PLANNING, ZONING, & BUILDING DEPARTMENT
PZ&B Staff Combination Memorandum: Landmarks Preservation Commission and Town Council

SUBJECT: HSB-22-016 (ZON-22-154) 353 PERUVIAN AVE (COMBO)

MEETING: MARCH 22, 2023 (LPC)
APRIL 04, 2023 (TC)

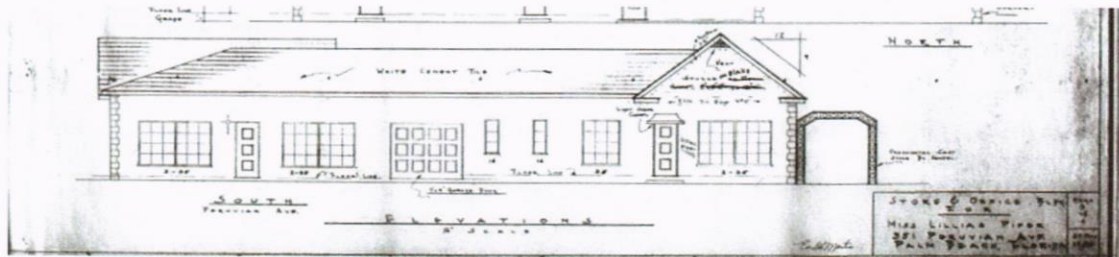
Variance #1 seeks to establish to the existing nonconforming setbacks of the original one-story retail structure, the improvements to the older historically significant structure will exceed both the 50% of the value improvements to the structure and 50% of the demolition of the rear façade, which triggers all of the building's nonconformances to be brought up to the today's zoning requirements. The historically significant building is already nonconforming in the north side setback, Variance #2, the existing side yard one-story setback for the existing structure is proposed to remain at 2.5' in lieu of the 10' minimum required. Staff would note that in the C-TS district, there is no minimum side yard required for one-story structures, but when a C-TS property adjoins property zoned in any R district, a ten-foot side yard is required on that side. Since the neighboring property is R-C, the increased setback is required. Additionally, the front yard setback is required to be 5'-0" for one-story structures under today's Code. The structure, as confirmed by the survey, is setback, 4.6' from the front property line along Coconut Row.

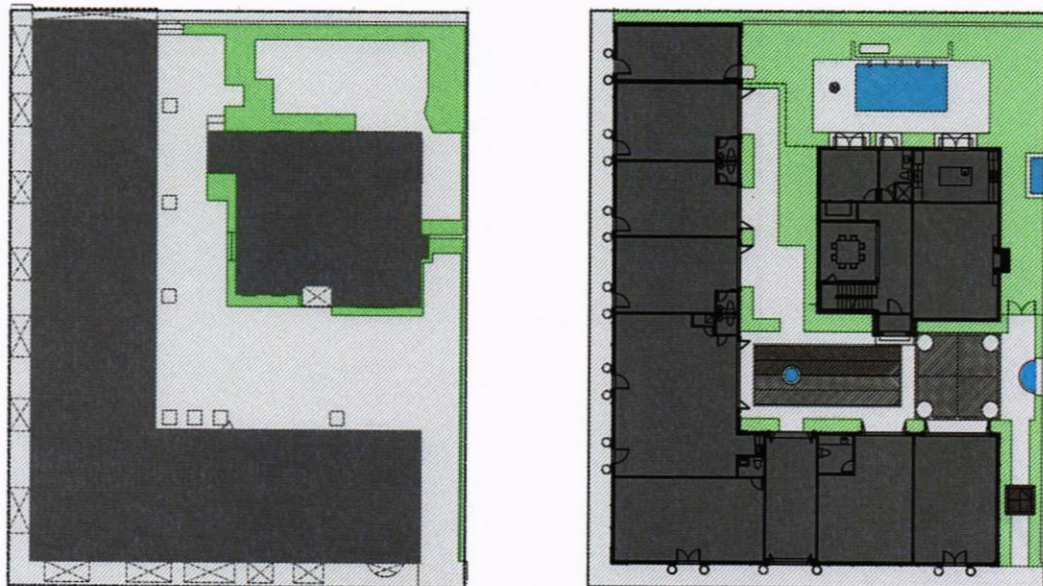
As it pertains to variance #4, to reduce the required overall open space. In the C-TS zoning district, the Code requires a 25% minimum overall landscaped open space for two-story buildings. The existing condition is 6% and the proposal seeks to increase that amount to 16.7%. It should be noted that for one-story structures, the requirement is 15%. The site contains both a one- and a two-story structure, requiring the more restrictive regulation to be applied. In order to create a viable commercial plaza, hardscape is desired to blend the indoor space into the outdoor courtyard through the use of operable Nana wall storefront systems, even still the applicant has applied green planting areas along the interior façade of the one-story retail liner building.'
